# SERVICE BULLETIN SB00.22

**Machines/Models:** LX31/41/50 w/outriggers

**PURPOSE:** Enhance Outrigger Durability

**PROCEDURE REQUIRED:** Replace the Outrigger Pressure Switch

**Figure 1**

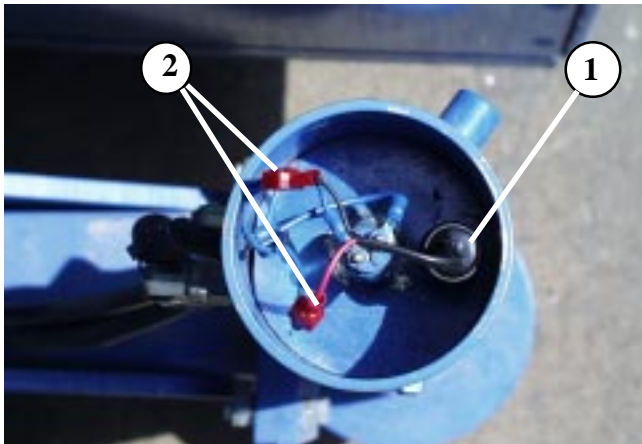
1. Remove the cap from the top of the outrigger.
2. Disconnect the electrical leads to the outrigger pressure switch (see Figure 1).

NOTE: Tighten the pressure switch by the base only, do not use the cap.

3. Replace the outrigger pressure switch with the supplied switch and torque to 25 ft lbs (35 Nm) .
4. Reconnect the wires to the new pressure switch
5. Repeat steps 1 through 4 for the remaining Three outriggers.
6. Perform Pre-Operation and Safety Inspection as instructed in the Operator Manual to ensure proper operation of machine.
